W.O. 45117	
LOCATION 3	4
LOCATION 1	2
HARRIMAN, TENN., SUB. - 69 KV.	
TENNESSEE VALLEY AUTHORITY POWER ENGINEERING AND CONSTRUCTION DEPARTMENT TRANSFORMER ACCESSORIES DIAGRAM MOLONEY 6667 KVA 1 ϕ TRANSF. 66000-7200/12470 Y VOLTS	
SCALE: None	SUBMITTED
DRAWN: NFP	DATE 2-4-52
TRACED: JHP	SHEET 1 OF 1 SHEET
CHECKED: LLL	HC-27997
CORRECT: AMS	
M.C. Charles	K.E. Hapgood

TENNESSEE VALLEY AUTHORITY
POWER ENGINEERING AND CONSTRUCTION DEPARTMENT
HARRIMAN, TENN. SUBSTATION-69kV
FENCE PLAN

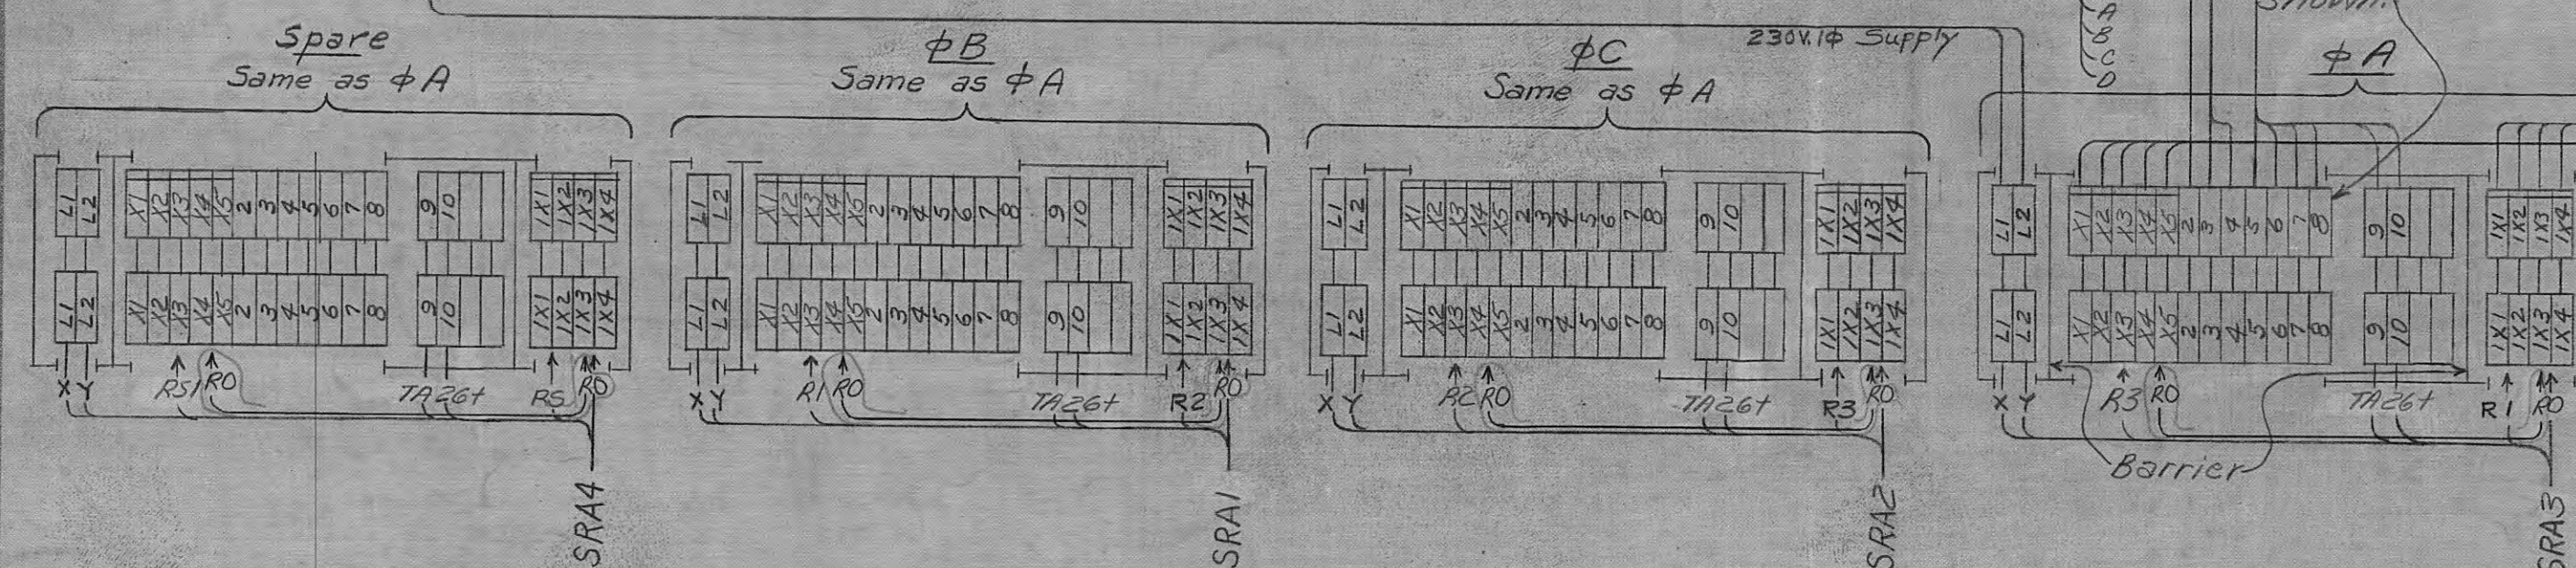
1. Replaced 12 pole blks. with short circuiting type; reset contact of winding temp. relay; disconnect fan A1 relay and copper temp. thermometer wires from term. block; wires R1 and 26 in cable SRA1 were sp & 0 respectively, wires R2 & 26 in cable SRA2 were sp & 0 respect., wires R3 & 26 in cable SRA3 were sp & 0 respect., wires R5, 26 & R5 in cable SRA4 were sp, 0, & R respect.; Added 600K CT on H2 bushing.

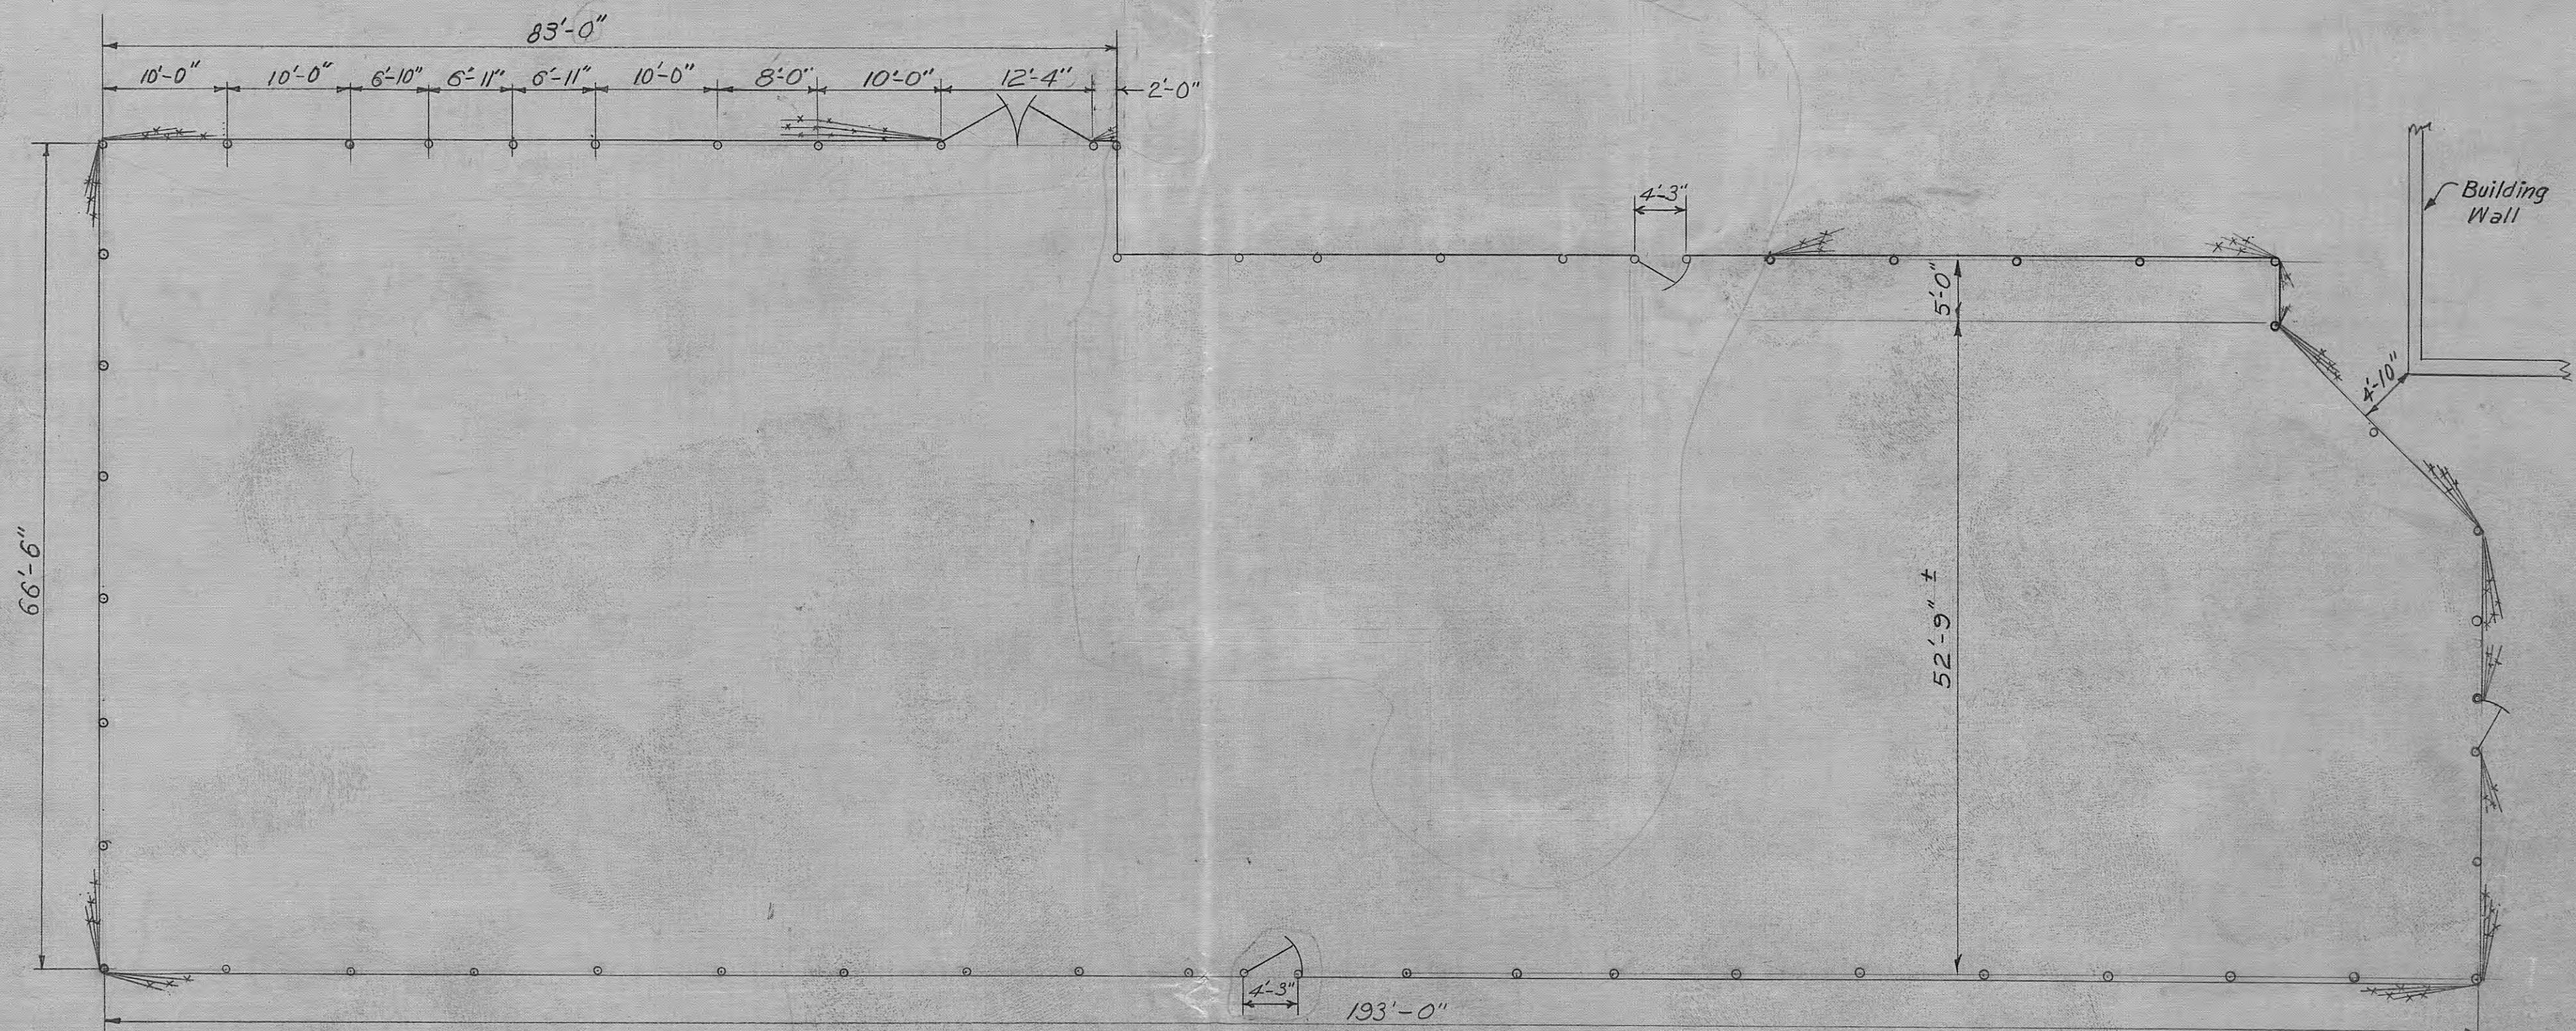
3	Fld. Chg. - Completion of WO. 35982	11-674	RJS	JHT
2	WO-35644 EXT. Fence	7-23-71	HJS	LEB
1	WO-47117 Extended Fence, Relocated Gate	7-23-51	CDK	
ISSUE	REVISION	DATE	SIG.
